MONTGOMERY COUNTY PLANNING DEPARTMENT

MEMORANDUM

Preliminary Plan of Subdivision

PROJECT NAME: Needwood Knolls

Attachment B – Proposed Development Plan

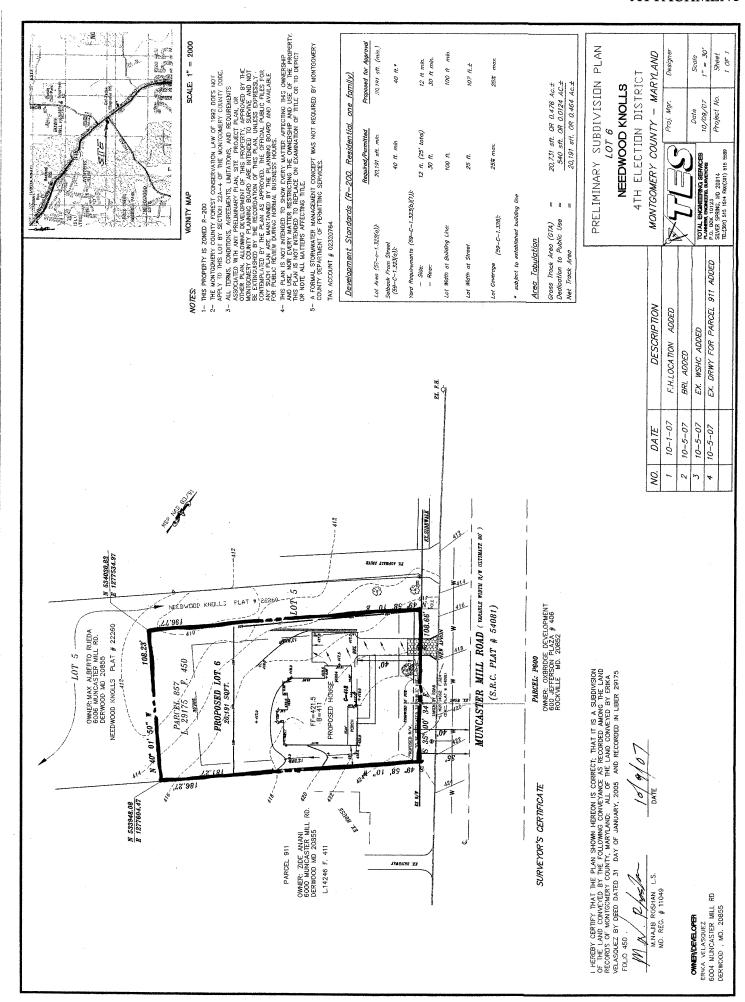
The applicant proposes to record 1 lot in order to accommodate a one-family detached residential dwelling unit. The proposed lot is 20,191 square feet, after proper dedication for Muncaster Mill Road is made. Access to the site is proposed from Muncaster Mill Road.

The proposed lots do not generate 30 or more vehicle trips during the morning or evening peak-hours. Therefore, the application is not subject to Local Area Transportation Review. Muncaster Mill Road is an arterial road, requiring 80 feet of right-of-way. The applicant proposes to dedicate additional right-of-way to provide 40 feet from the centerline as required. The Subject Property is located along the Alternative Route for the Intercounty Connector (ICC) bikepath. The applicant is not required, however, to construct a portion of the path because of the small amount of frontage along Muncaster Mill Road and because the plan includes only 1 replacement dwelling unit. A driveway with an apron along the Property frontage is proposed to serve the lot. Proposed vehicle and pedestrian access for the subdivision will be safe and adequate with the proposed public and private improvements.

- 1) Approval under this preliminary plan is limited to 1 lot for 1 one-family residential dwelling unit.
- 2) The record plat must provide for right-of-way dedication of 40 feet from the centerline for Muncaster Mill Road.
